## Riley-Purgatory-Bluff Creek Watershed District Permit Application Review

**Permit No:** 2023-044

**Project:** The applicant proposes trail improvements at three sites (#1-Topaz Dr and Lucy Ridge Circle, #2-South Lotus Lake Park, and #3- Galpin boulevard) in Chanhassen, MN.

**Reviewer:** Katherine Tomaska, EIT and Scott Sobiech, PE Barr Engineering

Figure 1

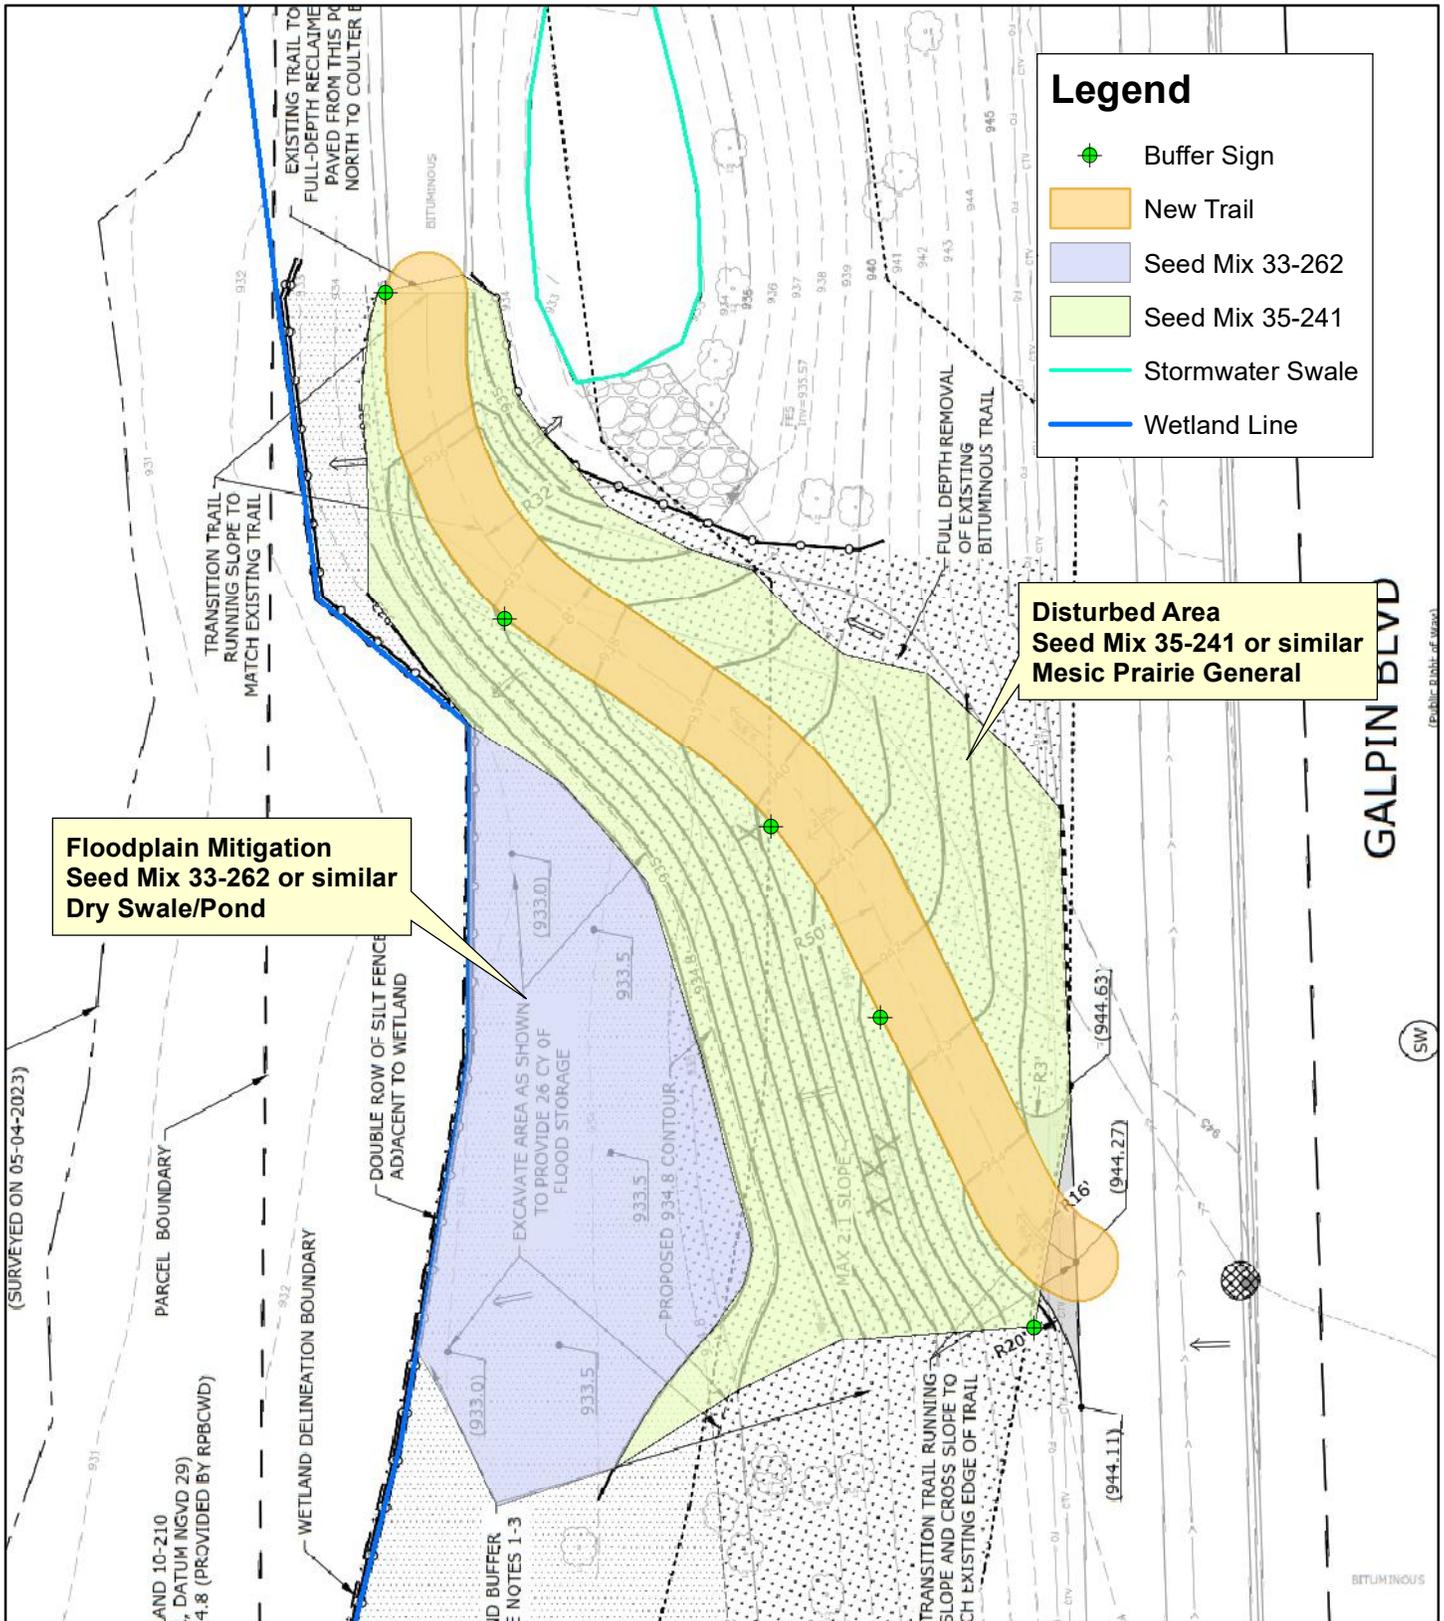
The proposed buffer variance area is to the west/southwest of the relocated trail segment. Figure 1 and plan sheet 4 label the non-compliant buffer widths to the south/southwest of the proposed relocated trail.

**Revegetation Areas**

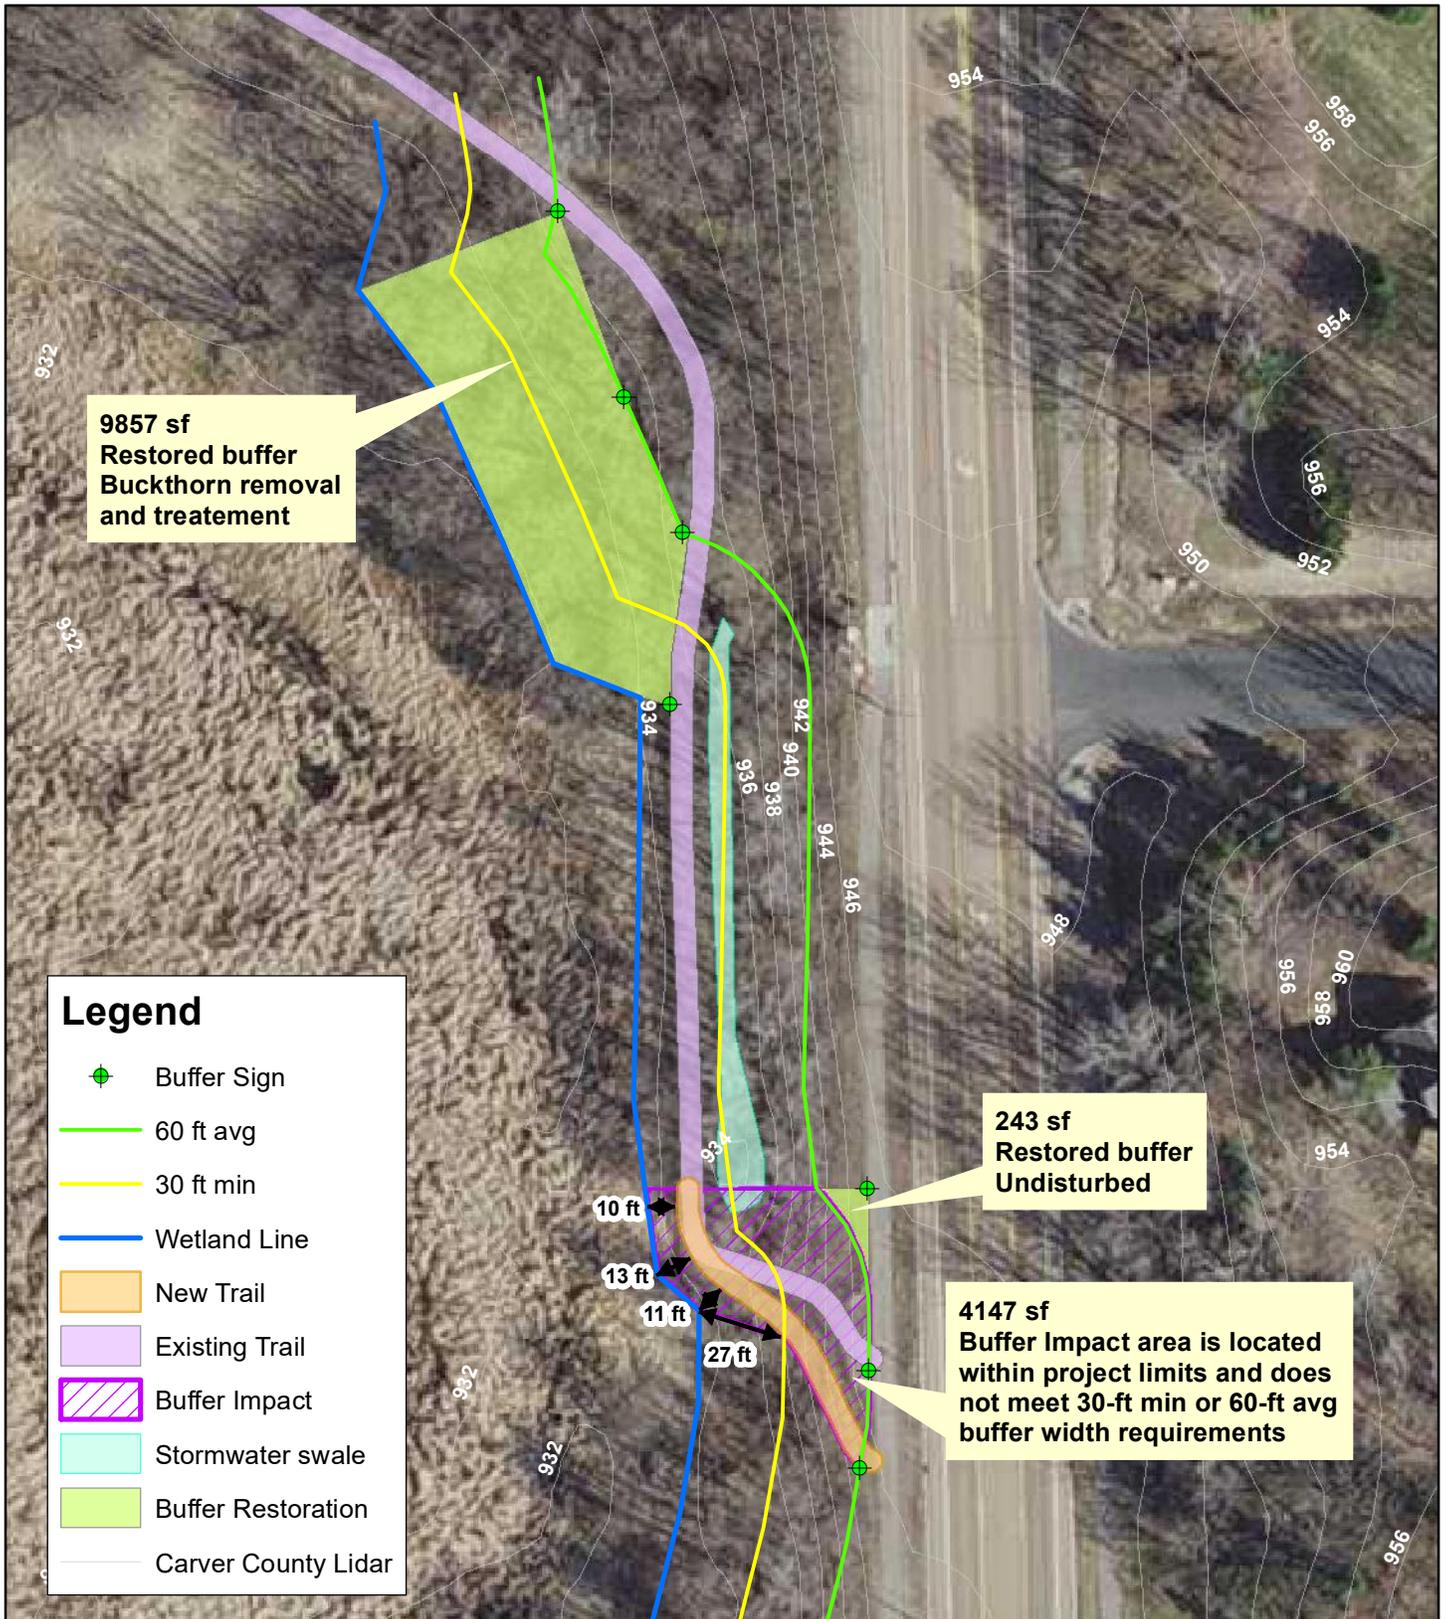
Because the existing trail and the proposed relocated trail do not meet current buffer width requirements, vegetative restoration of existing buffer to the north of the project area (Figure 2 and plan sheet 5) is proposed to compensate for the deficit of total buffer area provided along the relocated trail segment. The project work will include removing and treating common buckthorn and other invasive species within this wooded buffer area. The buffer restoration area is proposed to be over twice as large as the impacted (deficit) buffer area.

CONSTRUCTION PLAN  
 GALPIN BLVD  
 TRAIL/WALK IMPROVEMENTS  
 CHANHASSEN, MN

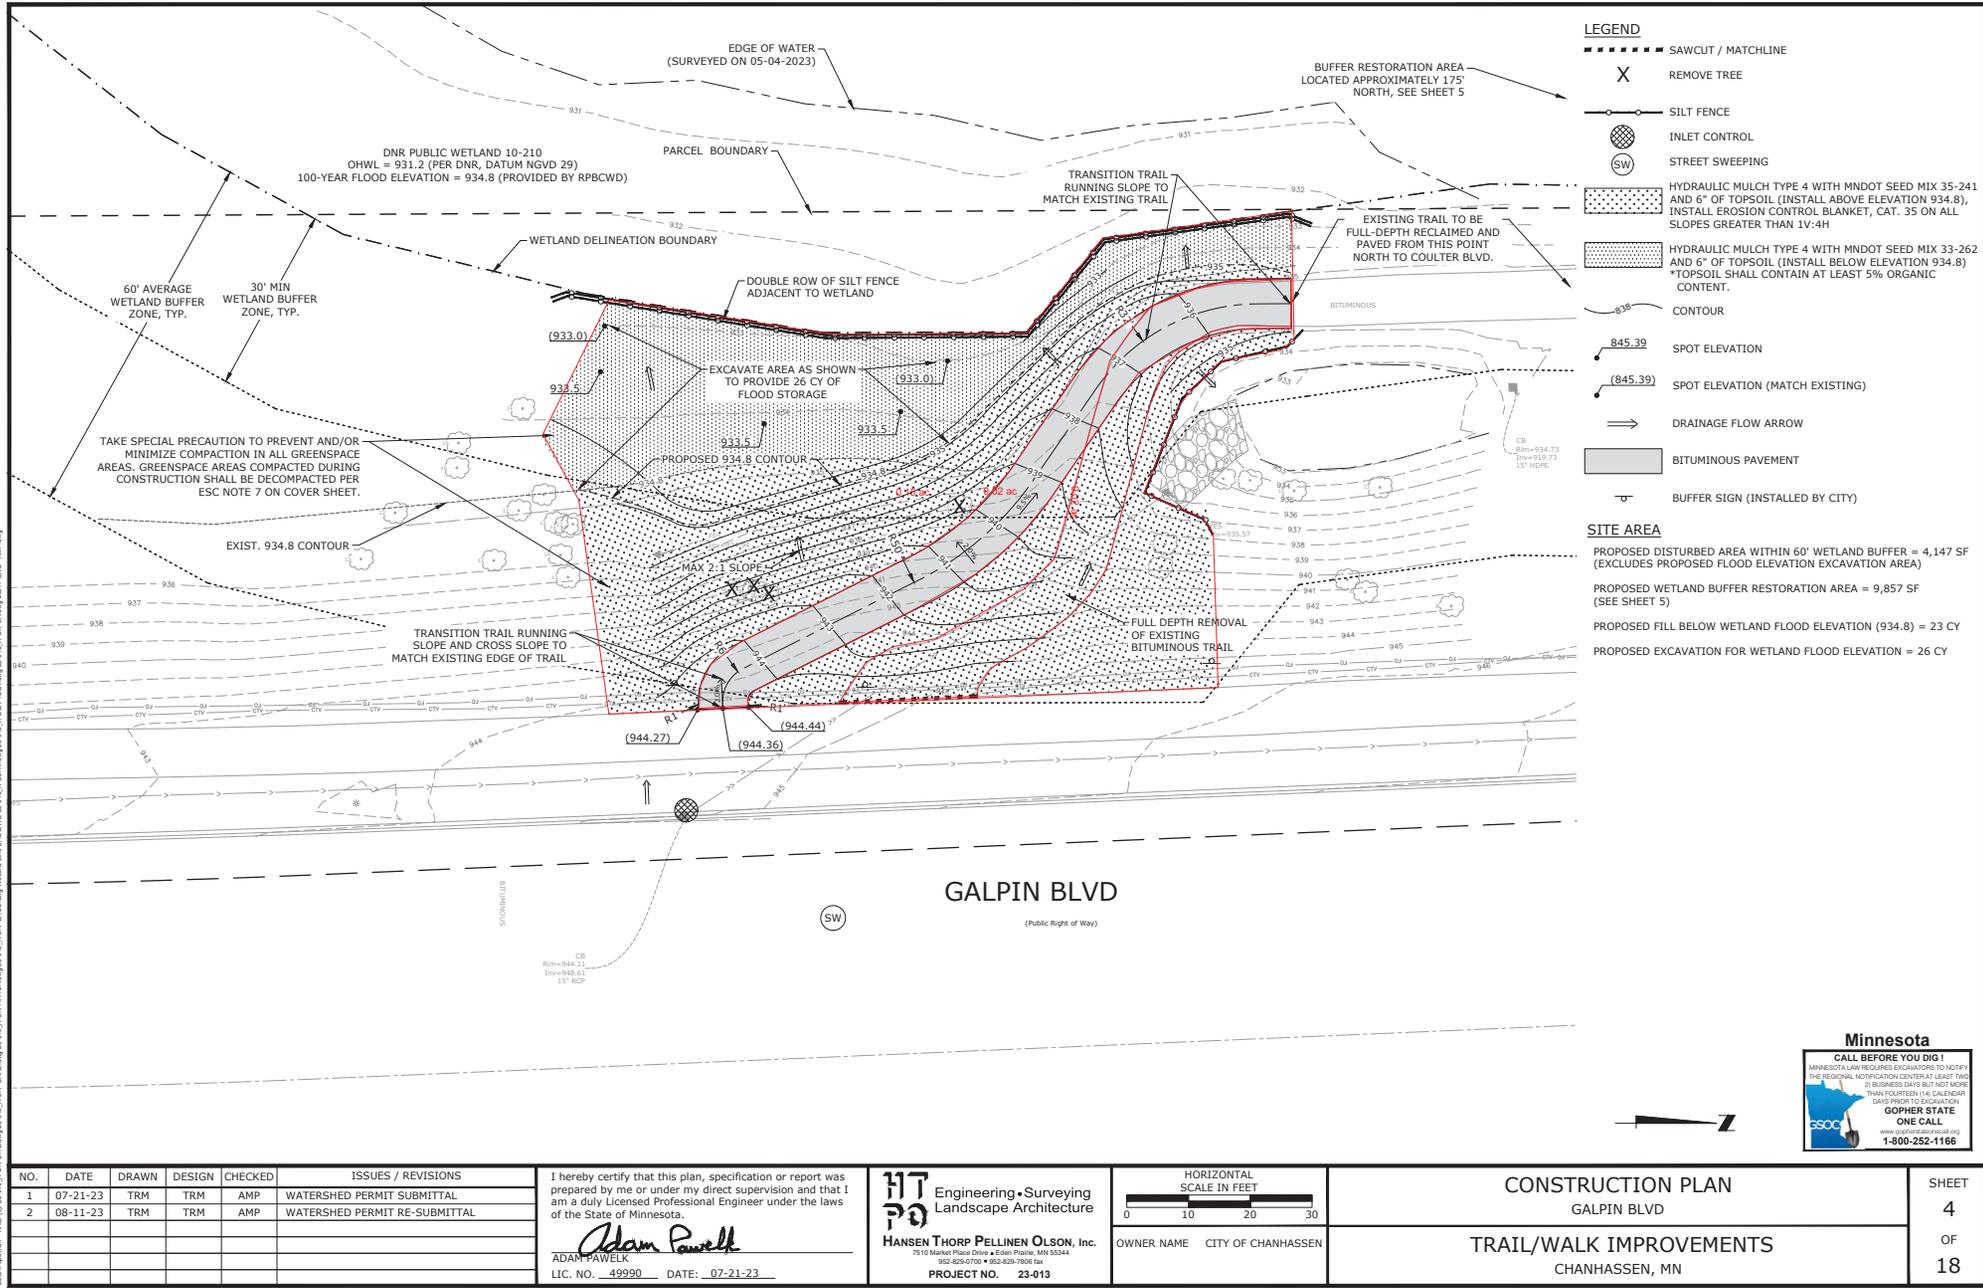
The relocated trail will be no closer to the wetland than the existing trail. Land that is disturbed for trail construction will be revegetated. Floodplain fill will be mitigated as detailed in the table below (see plan sheet 4). The floodplain mitigation area will also be revegetated. Therefore, the project will not adversely affect the water resource (the wetland).
